Giant Mine Environmental Assessment IR Response Template

Round One: Information Request – Review Board #24

EA No: 0809-001

Information Request No: Review Board #24

Figure 1: Wind Occurrences (in percent) for Major Directions at Yellowknife Airport Station, for the Period from May to October.

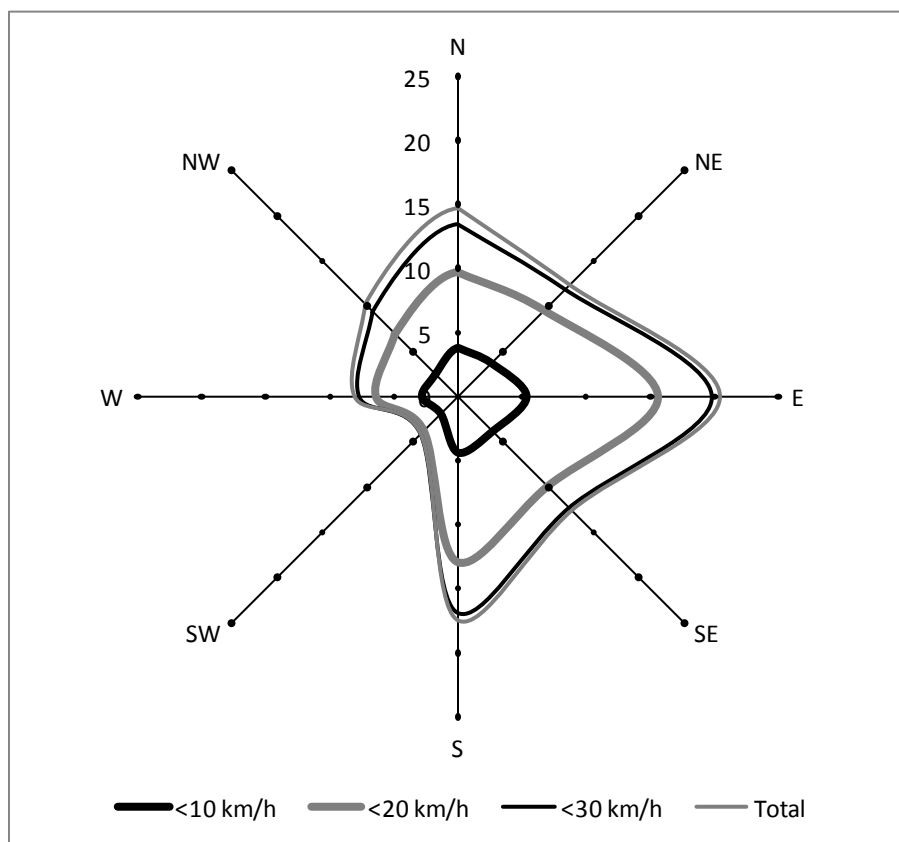
1. For each diffuser location, please describe and illustrate the currents in the bay in the various seasons, at a scale that encompasses the local study area, to identify where effluent ultimately travels. Does this water go to Ndilo, Latham Island, Back Bay, Yellowknife Bay (houseboat community) or Dettah? Describe the potential, over the long term, for this to result in arsenic sediment loading in any of these areas.
2. Please provide the model, if any, that is the basis for conclusion that “thermal loading is not expected to be an issue”, considering currents during ice conditions. IF there is no model, please provide a detailed analysis.
3. Is INAC able to restrict access to the surfaces of frozen water bodies, as identified as a possible mitigation in Table 8.4.5? If so, please describe how.

During the open water period, from May to October, winds recorded at Yellowknife Airport station are often coming from the east (45% of wind occurrences for the combined north-east, east and south-east directions), with frequent occurrences from the South (18%) and North (15%). However, winds have been observed in all major directions. Consequently water currents in the bay can be directed in any direction at any given time, depending on prevailing wind conditions. Flows from the Yellowknife River induce water currents to be directed towards Great Slave Lake.
